Design Review Board

DESIGN REVIEW BOARD – NEIGHBORHOOD PANEL A G E N D A Regular Meeting November 3, 2016; 3:00 pm 10th Floor Council Chambers, City Hall

Planning Staff Report to Design Review Board - Neighborhood October 27, 2016

Residential, view lot plan spec H 玄 2nd Earl REVISION CHANGES:

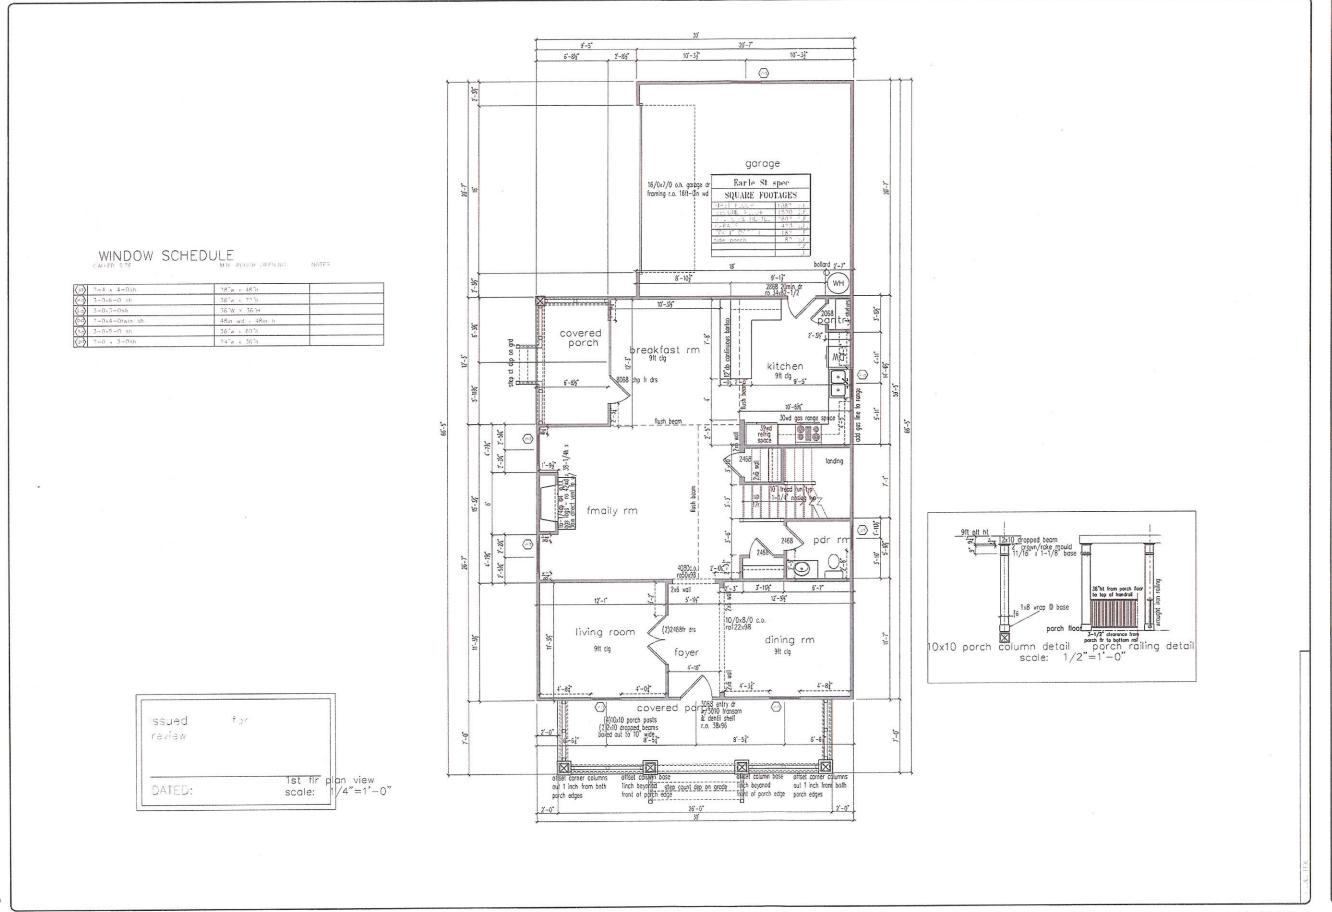
- 1. Additional windows to be included on the side elevations in Bedrooms 2 and 3:
- 2. All windows to be at least simulated divided lite, wood or metal-clad wood: and
- 3. Staff to approve window selection and placement.

At staff's request, applicant has increased the depth of the roof overhangs, provided information on detail of porch railing, and evaluated the arrangement of windows on the side elevations.

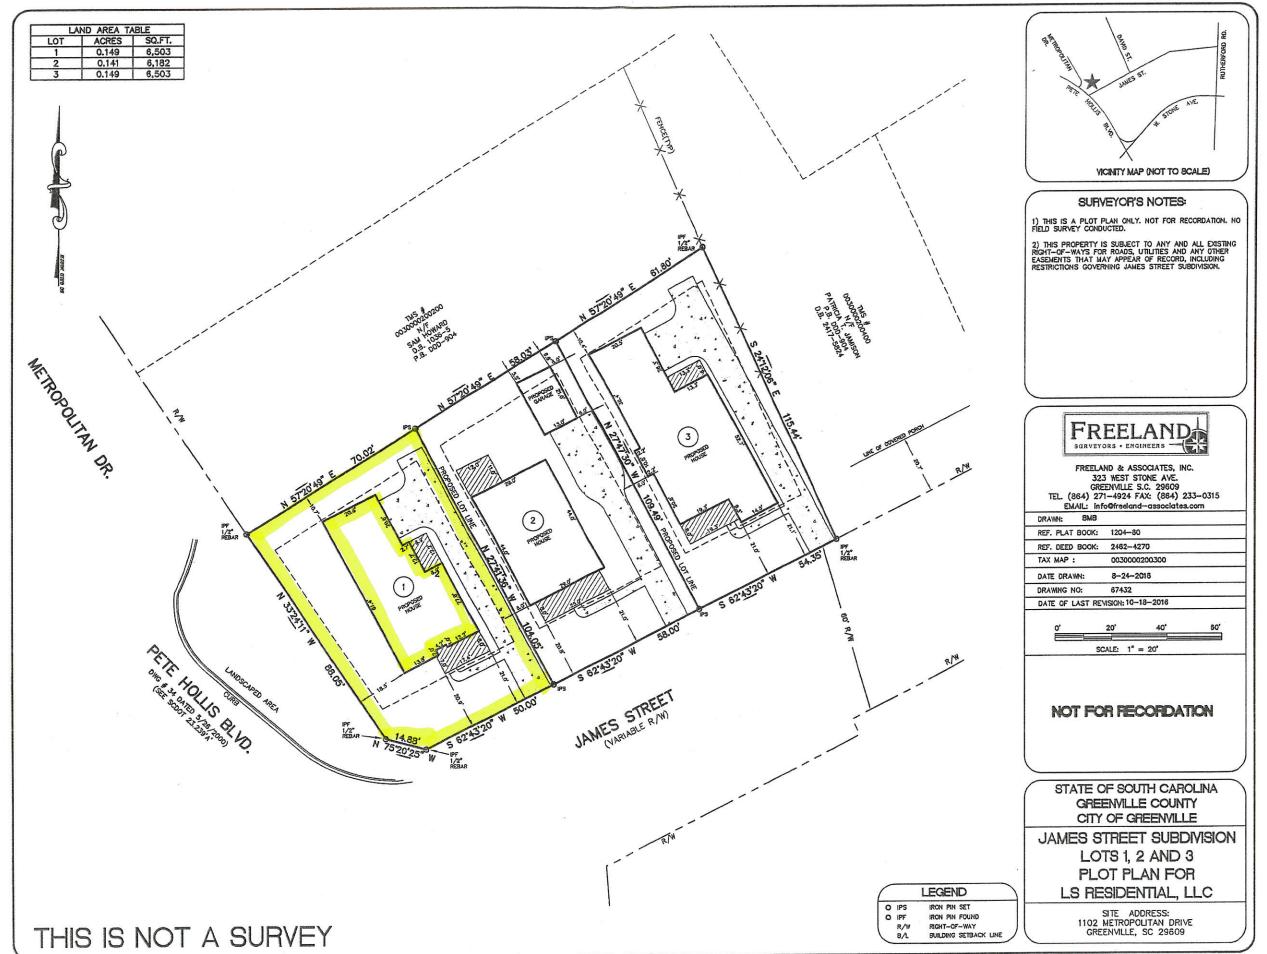
- 1. Additional windows to be included on the right side elevation in Bedrooms 3 and 4;
- 2. All windows to be at least simulated divided lite, wood or metalclad wood: and
- 3. Staff to approve window selection and placement.

At staff's request, applicant has flipped the houses on lots 1 and 2, increased the depth of the roof overhangs, provided information on detail of porch railing, increased the depth of front porch to 8', varied window grid pattern among the three houses, and evaluated the arrangement of windows on the side elevations.
